THE CITY OF EDINBURG

INVITATION TO BID ADDENDUM NUMBER ONE (1)

RE: BID NO. 2012-63 – MANHOLE REHABILITATION PROJECT

MANHOLE REHABILITATION
STANDARD DETAILS

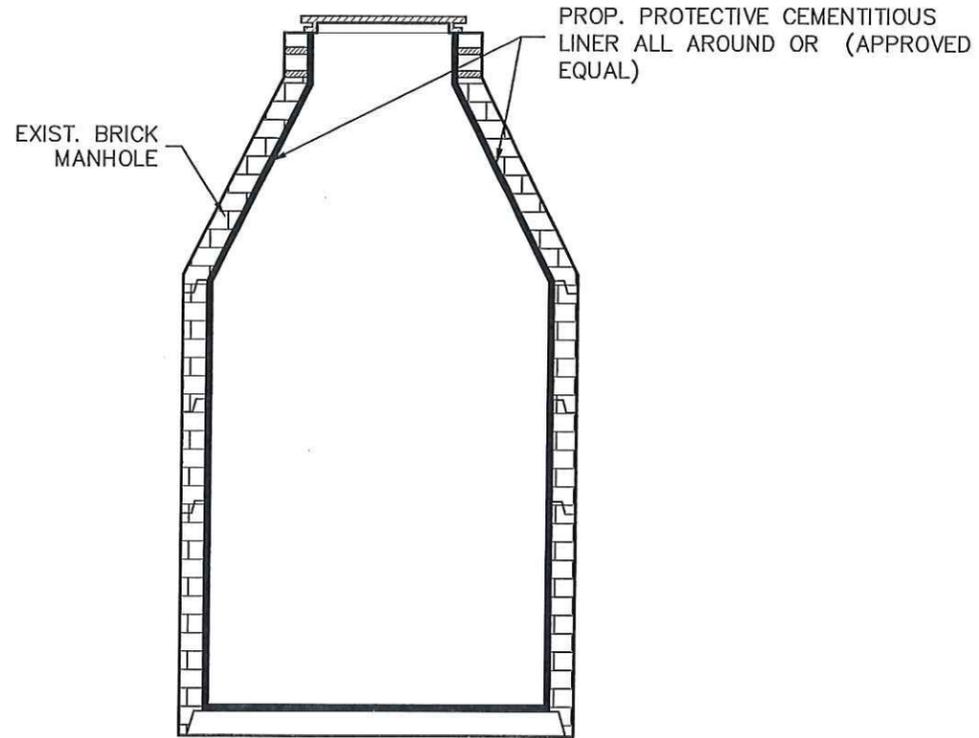
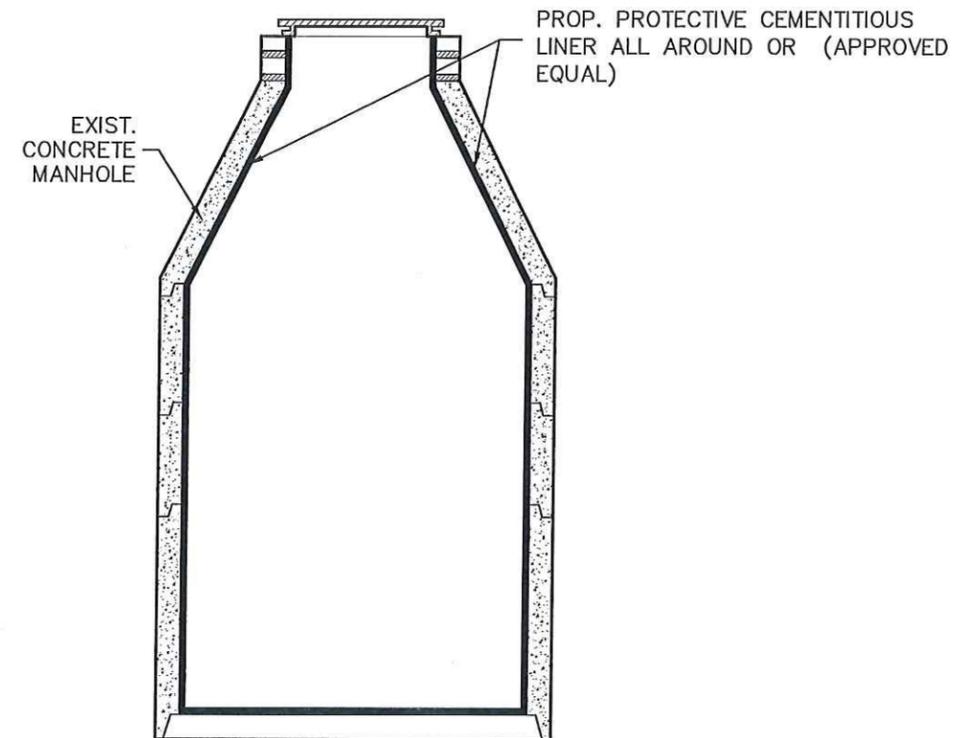
1. Sheet 7, Note #7 – Removal of Note #7 – Replace with attached “ Sheet 7”

NO.	REVISION	DATE
7	REMOVED NOTE NO. 7	03/14/12
